**SLUP-19
(2008)**

SPECIAL LAND USE PLAT FOR
ATLANTA HARDWOOD CORPORATION

PETITION NO: SLUP-19

PROPOSED USE: Chipping, Grinding And Reduction Of Trees And Logs

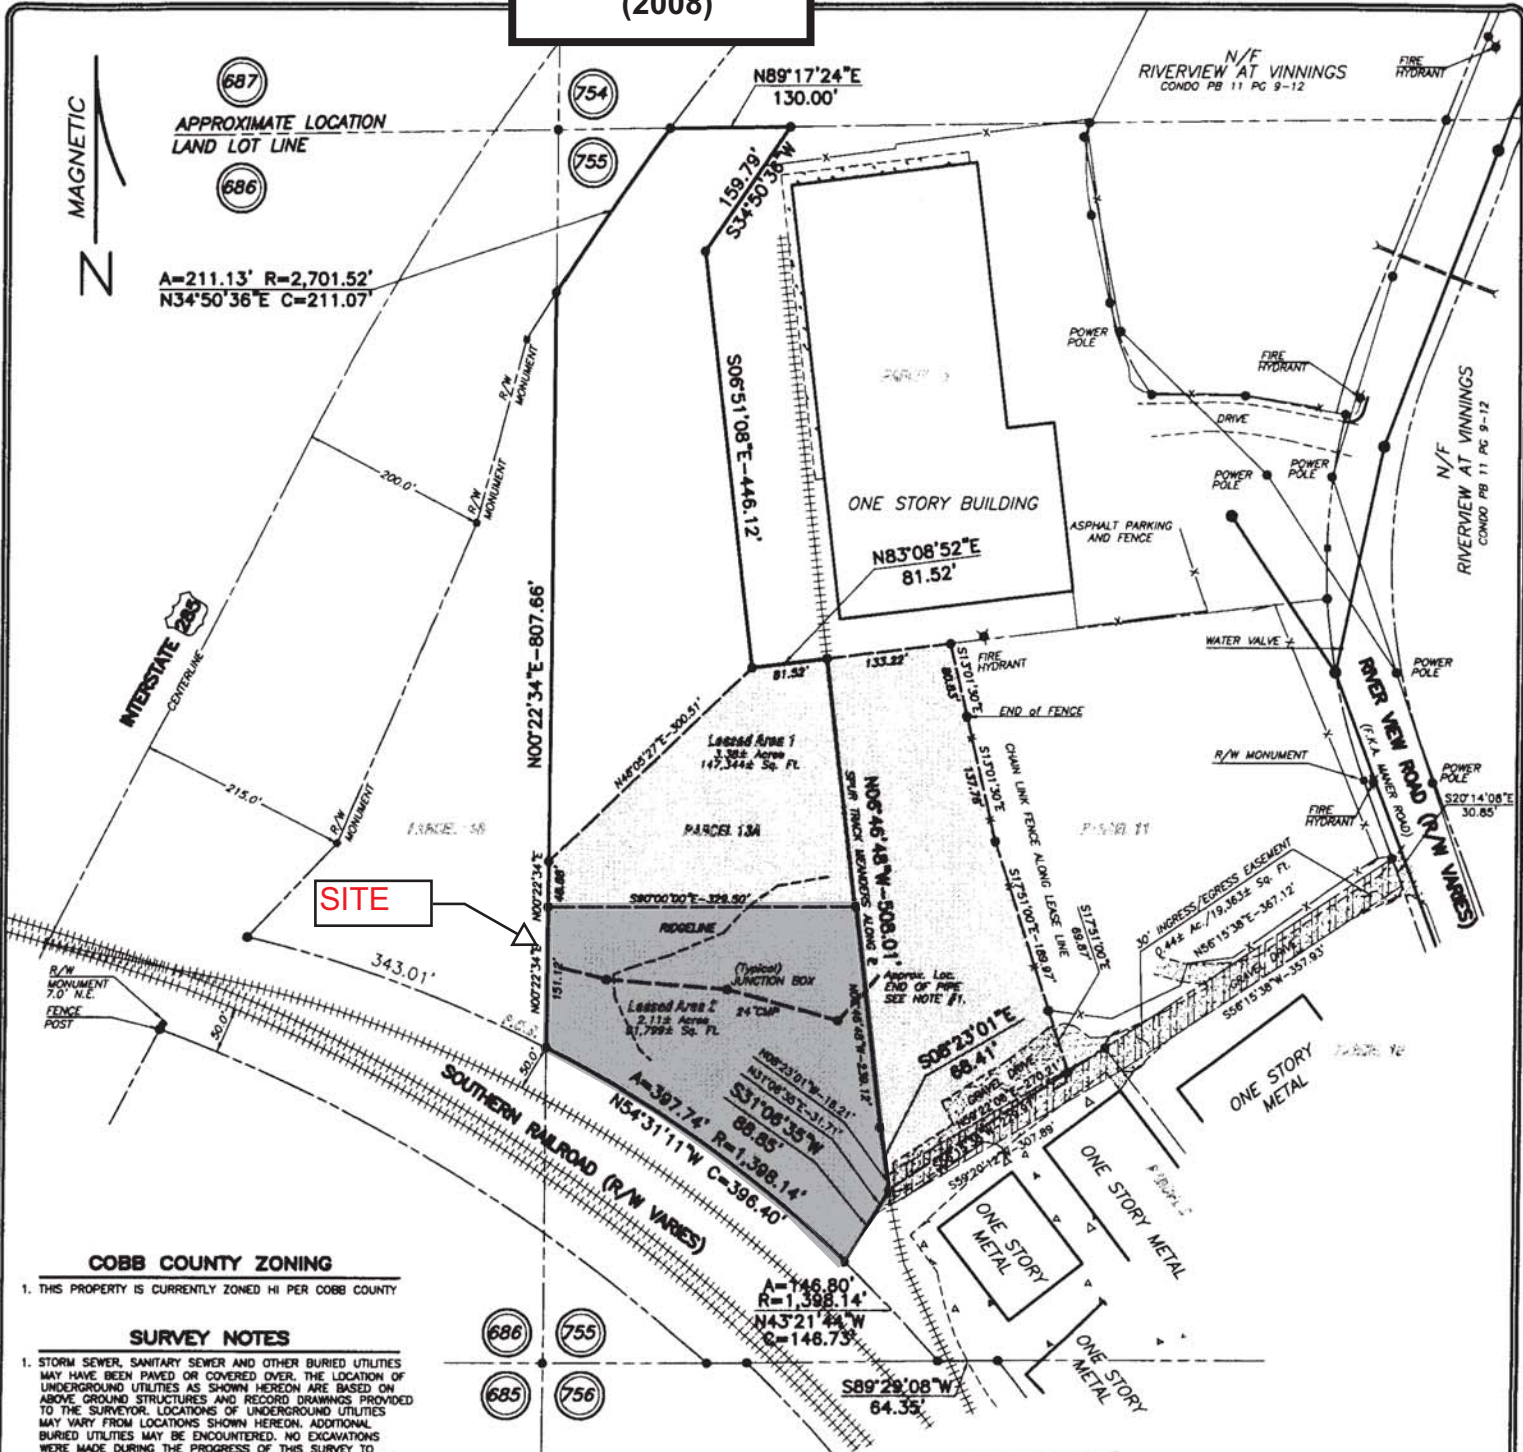
Water and sewer not available to 2.11 acre tract.

Recommend applicant be required to meet all Cobb County Development Standards and Ordinances related to project improvements.

1. No improvements are proposed for the site. However, it is recommended that Silt Savers (or similar storm inlet protection BMPs) be provided for any existing drop inlets located on the site. It is also recommended that a mulch berm be established along the western perimeter of the property to provide for any potential erosion that may occur on the site.

- Site plan received by the Zoning Division on August 7, 2008;
- Water and Sewer comments and recommendations;
- Stormwater Management comments and recommendations; and
- DOT comments and recommendations.
